INITIAL FIRE SAFETY INSPECTION REPORT

Factory Name: Sterling Designs Limited (Extension)

Date: 10th Nov 2024

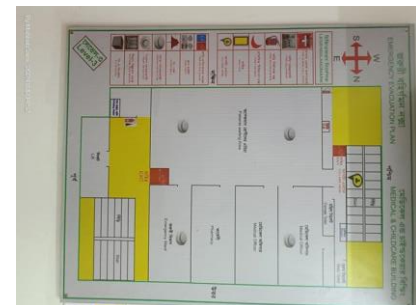
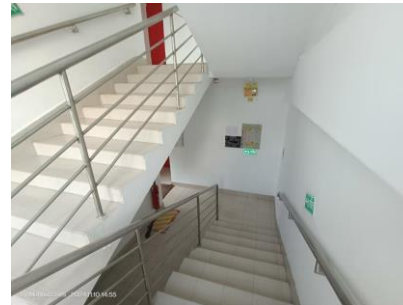
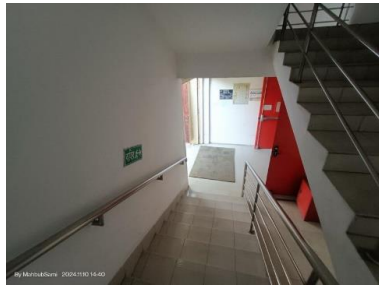
SI No.	Category	Findings	Required Action	Remediation Time Frame
F-1	Fire Rated Construction	<p>Unsealed penetrations and openings are located in the fire-rated floor/ceiling assemblies due to Plumbing Pipes, Electrical Cable Riser and unprotected opening connecting ground floor to 1st floor having different occupancies. Location: Building-2 (4-Storeyed Medical & Childcare).</p>	<p>Seal all penetrations and openings in floor/ceiling assemblies to maintain the fire separation at least by 3-hr. The used sealer shall be 3rd party certified and installation shall be as per manufacturer's guideline. (Type-1 Construction).</p> <p>or,</p> <p>Provide a minimum 2-hr fire rated shaft to separate the utility risers from each floor if required. (Type-1 Construction).</p>	Within 3 months
<div style="display: flex; justify-content: space-around;">   </div>

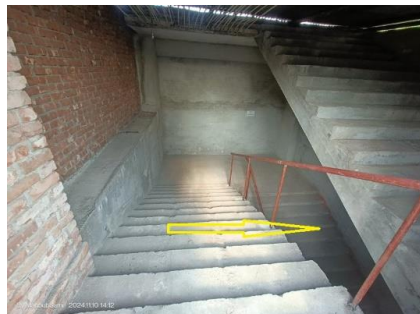
F-6	Means of Egress	<p>Width of exit stairs are less than 1.5 m (60 in.) and means of egress continuity was not maintained. Location: Building-3 (Utility Building) & Building-2 (Medical & Childcare).</p>	<p>In new and interim construction and constructed stairs post 24 November 2013, stairs shall have a minimum width of 1.5 m (60 in.) for all industrial occupancies in accordance with RSC standard 6.5.6.2.1.</p>	Within 3 months
-----	-----------------	--	--	-----------------
